UNITED STATES PATENT AND TRADEMARK OFFICE

APPLICATION NO.	FILING DATE	FIRST NAMED INVENTOR	ATTORNEY DOCKET NO.	CONFIRMATION NO.
10/052,667	01/18/2002	Jin Qiu	MIT9126	5628

Office Action Summary	Applicati n No.	Applicant(s)	
	10/052,667	QIU ET AL.	
	Examin r	Art Unit	
	Anatoly Vortman	2835

DETAILED ACTION***Claim Rejections - 35 USC § 102***

FIG. 1A**Prior Art*****FIG. 1B*****Prior Art**

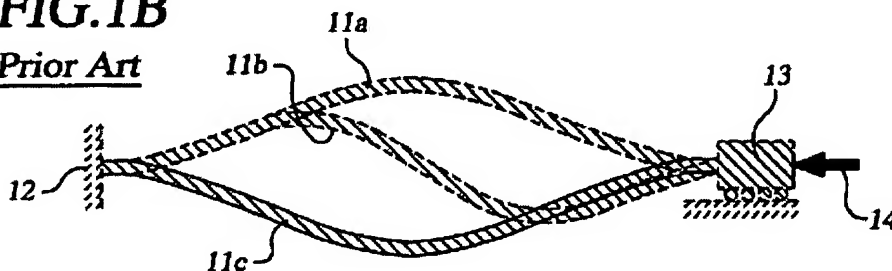
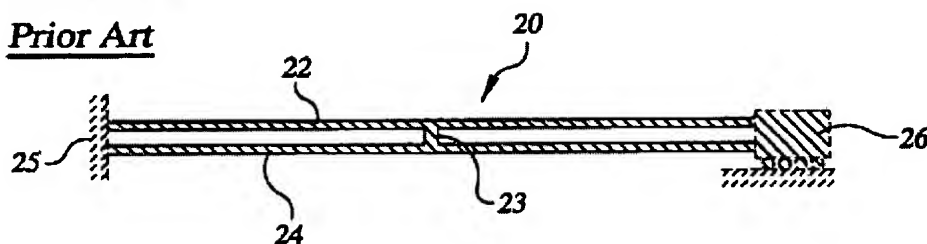
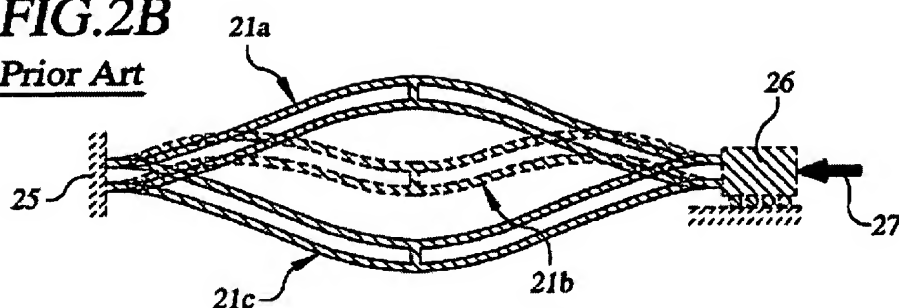
2. Claims 1-8, 11-13, 15, and 18, are rejected under 35 U.S.C. 102(a) as being clearly anticipated by the Applicant's Admitted Prior Art (AAPA).

AAPA teaches (Fig. 1A-2B) a bistable MEMS structure as recited in the claims:

Regarding claim 18, the AAPA bistable structure inherently has a mechanical force applicator, so the structure can move upon application of the force as shown on Fig. 2A and 2B.

FIG. 5

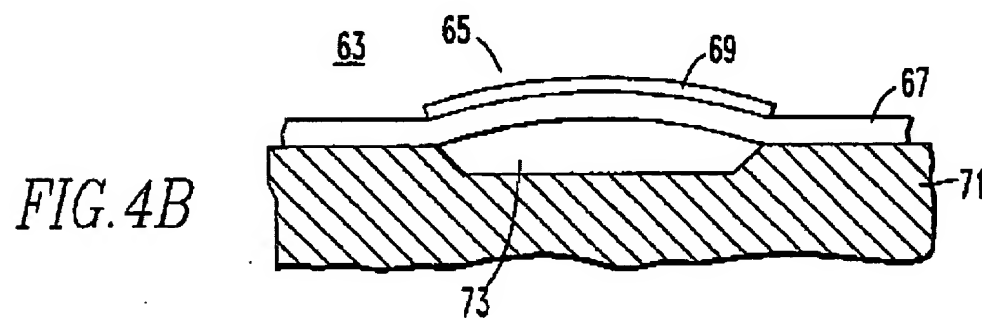
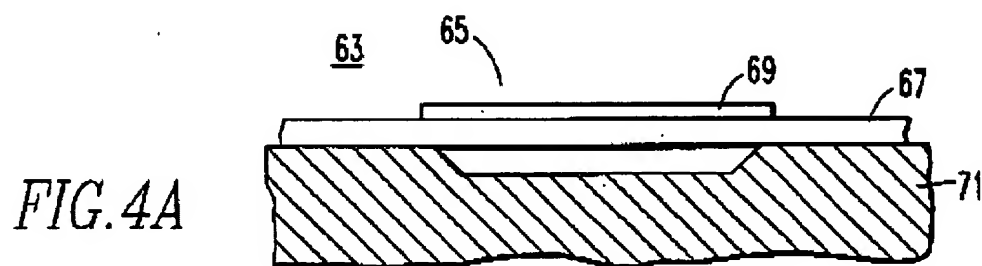
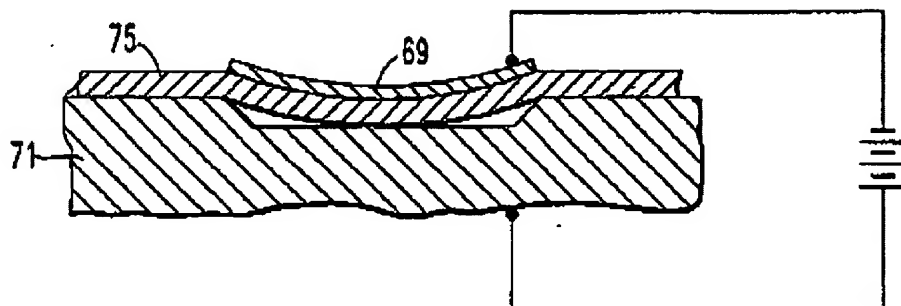
3. Alternatively, claims 1, 2, 4, 5-8, 13, 15, and 18 are rejected under 35 U.S.C. 102(b) as being clearly anticipated by US/5,659,171 to Young et al., (Young).

Young disclosed (Fig. 4A, 4B, and 5) a bistable MEMS structure as recited in the claims:

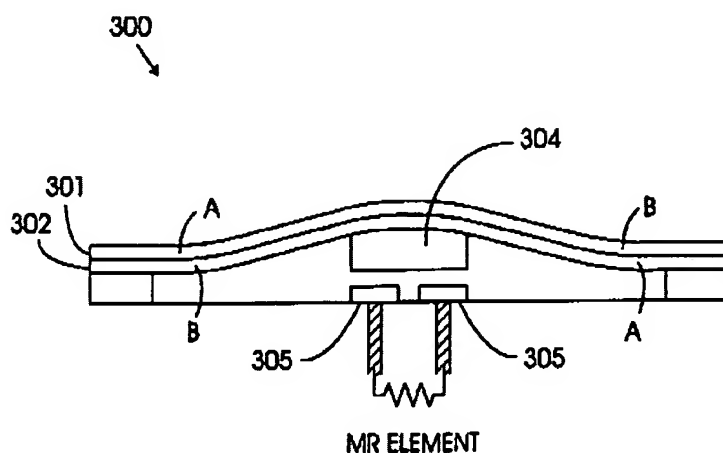
AAPA or Young disclosed all, but electrical contacts contacting with electrically conducting cross bar.

Albrecht teaches MEMS structure (see Fig. 3 below), including electrical contacts (305) electrically contacting the cross bar (304) for providing the structure with switching capabilities (column 7, lines 58+).

FIG 1A

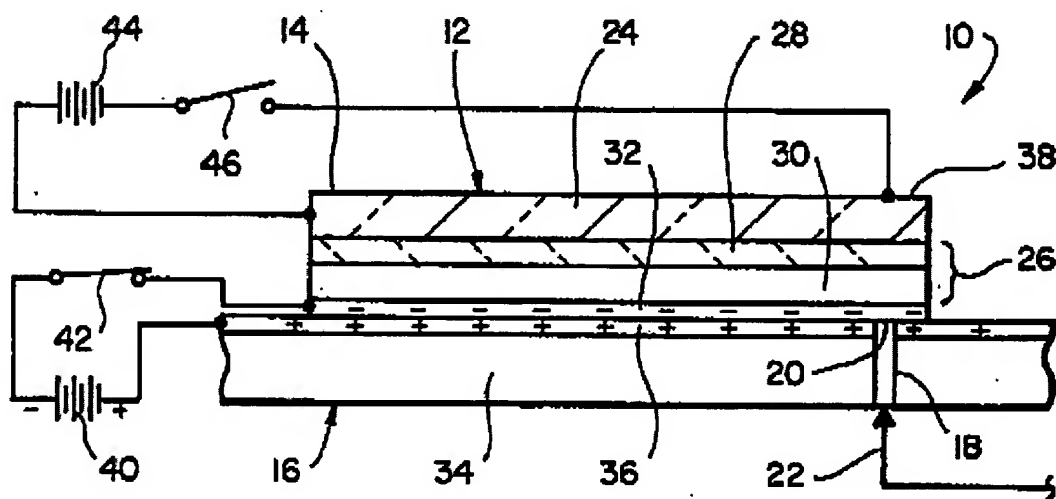
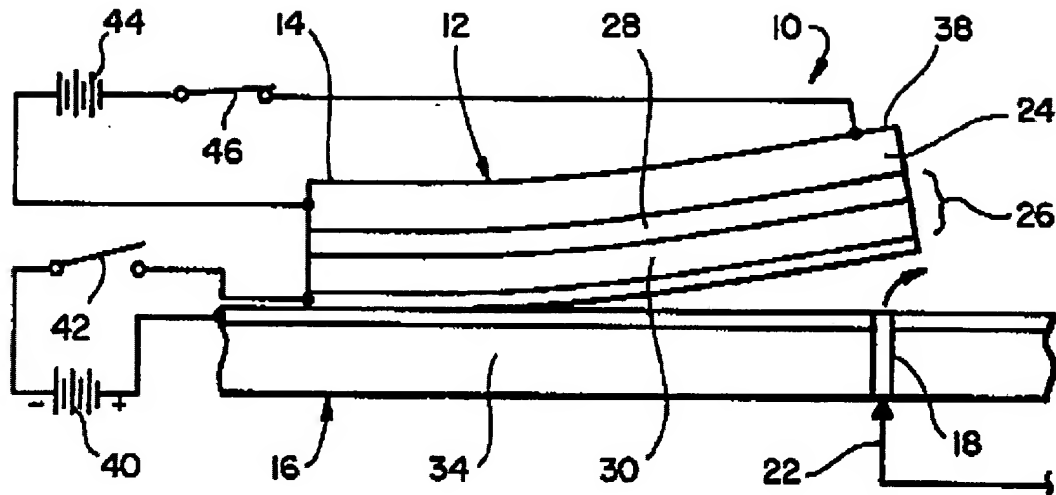
AAPA and Young disclosed all, but that the actuation force is thermal or electrostatic.

Johnson disclosed MEMS having both: thermal and electrostatic actuation (Fig. 1A, 1B):

It would have been obvious to a person of ordinary skill in the MEMS art at the time the invention was made to provide AAPA or Young device with thermal and / or electrostatic actuation as taught by Johnson in order to enhance control characteristics of the AAPA or Young MEMS.
